Access Compliance Report Public Rights-of-Way (Curb Ramps)

Main Street: GILBERT_ST Cross Street: PACIFIC_AVE Location: SW

ADA ID: RPRK210922121821 Ramp Type: Type 4 - Parallel Initial Pass/Fail: Pass Overall Compliance: No Severity Score: 30

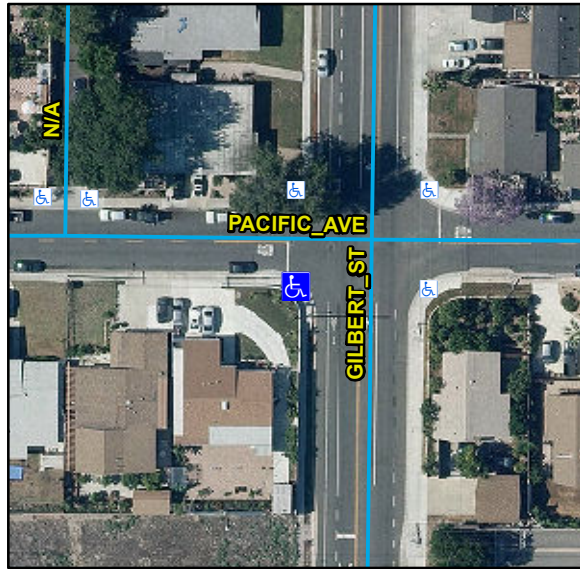
Compliance	Description	Data	Compliance	Description	Data
N/A	Ramp Length LT (in)	89	N/A	Ramp Length RT (in)	72
Yes	Ramp Width LT (in)	60	Yes	Ramp Width RT (in)	60
Yes	Ramp Run Slope LT (%)	3.4	Yes	Ramp Run Slope RT (%)	1.4
No	Ramp Cross Slope LT (%)	7.6	Yes	Ramp Cross Slope RT (%)	1.4
N/A	Landing Present	Yes	Yes	DWS Provided	Yes
N/A	Landing Length (in)	60	Yes	DWS Contrast	Yes
Yes	Landing Width (in)	48	Yes	DWS Length (in)	36
Yes	Landing Run Slope (%)	1.4	Yes	DWS Full Width	Yes
Yes	Landing Cross Slope (%)	1.6		DWS Offset Type	Single
N/A	Landing Movement Obstructed?	No	Yes	DWS Offset Left (in)	0
	Landing Movement Type	Curb	Yes	DWS Offset Right (in)	N/A
N/A	Landing Shared	No			
N/A	Clear Space	Yes			
N/A	Clear Space To Crosswalk (in)	48			
N/A	Marked Crosswalk 1	No	N/A	Marked Crosswalk 2	No
	Crossing 1 Direction	E		Crossing 2 Direction	N
N/A	Marked Crosswalk 1 Width (in)	N/A		Marked Crosswalk 2 Width (in)	N/A
N/A	Ramp Inside Crosswalk 1	N/A	N/A	Ramp Inside Crosswalk 2	N/A

Crossing 1 Slope (%)	3.7		Crossing 2 Slope (%)	3.7
	Crossing 1 Cross Slope (%)	2		Crossing 2 Cross Slope (%)	1.3
Yes	Gutter Ponding	No	No	Curb Slope	9.6
Yes	Gutter Lip Height (in)	0		Road Run Slope (%)	1.4
Yes	Gutter Run Slope (%)	4.8		Road Cross Slope (%)	4.6
Yes	Gutter Cross Slope (%)	1.9	Yes	Perpendicular Joint Present	Yes
Yes	Overall Surface Condition	Acceptable			
	Cross Gutter Present?	No		Spandrel Present?	No
	Replace Cross Gutter?	N/A		Replace Spandrel?	N/A

Remove & Replace Curb Slope. Remove & Replace Sidewalk. Utility Present.

R304.2.2, R304.5.3, STD 1115
